STAFF SUBMITTAL

Application for Stream Channel Alteration Permit (SCAP.3528.2)
Streambank Stabilization, Moloa'a Stream
Declaratory Ruling No. DEC-ADM12-01
Moloa'a, Kauai (TMK: (4) 4-9-014:021)

Application for Stream Channel Alteration Permit (SCAP.3528.2), to reinforce and stabilize streambank, Moloa'a Stream, Moloa'a, Kauai (TMK: (4) 4-9-014:021).

Exhibit 7: Cross-section of Moloo'a stream (see Exhibit 3 for location) showing proposed placement of boulder rip rap.

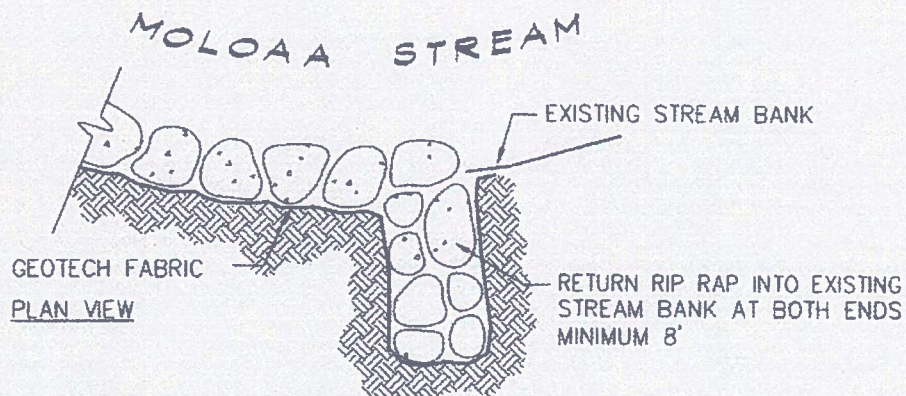
3. Section A-A included in the permit application is a schematic representation that does not faithfully portray the present geometry of the stream cross-section (Exhibit 7).

4. The applicant proposes to embed, to a depth of 1.5 times the rip rap diameter, the lowest course of boulders in the stream bed, but does not explain how this will be accomplished in the presence of the bedrock shelf or exactly where in the stream bed the trench will be excavated (Exhibit 7).

5. The applicant proposes to grade successive courses to create a 45° (1:1) slope (Exhibit 7), but does not explain how it will be possible to do this without backfilling behind the proposed rip rap installation and specifies that no fill other than rip rap will be used.
